UNITED STATES PATENT AND TRADEMARK OFFICE  
**CERTIFICATE OF CORRECTION**

PATENT NO. : 7,287,208 B2  
APPLICATION NO. : 10/814449  
DATED : October 23, 2007  
INVENTOR(S) : Dybsetter et al.

(54) **TWO-WIRE INTERFACE HAVING  
EMBEDDED PER FRAME RELIABILITY  
INFORMATION**

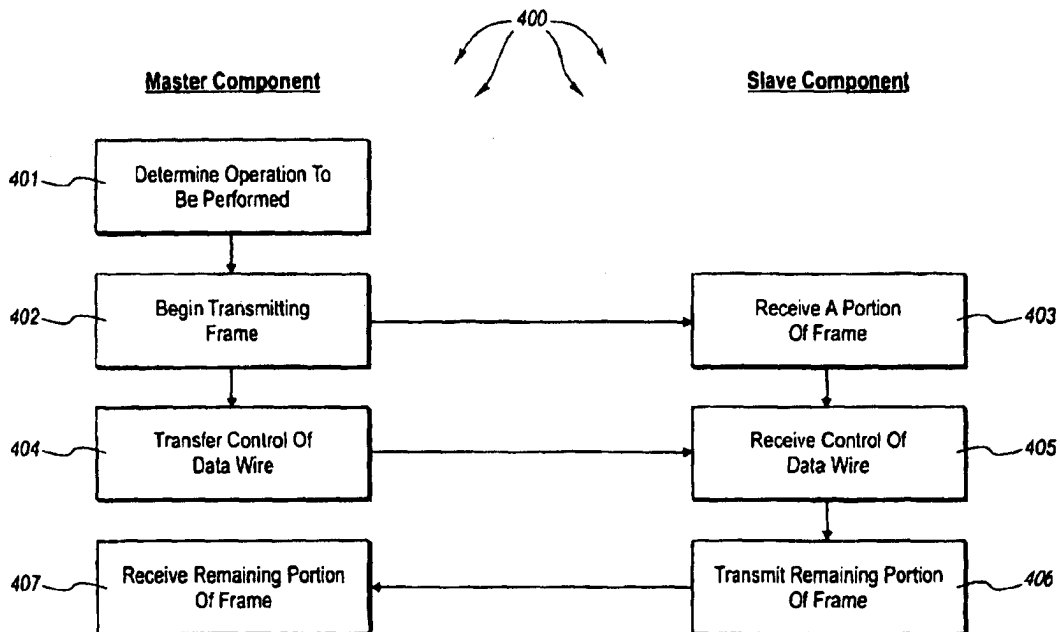
Sheet 5, replace Figure 4 with the figure depicted herein below, wherein the second instance of "405" referring to "Transmit Remaining Portion of Frame" has been changed to --406--
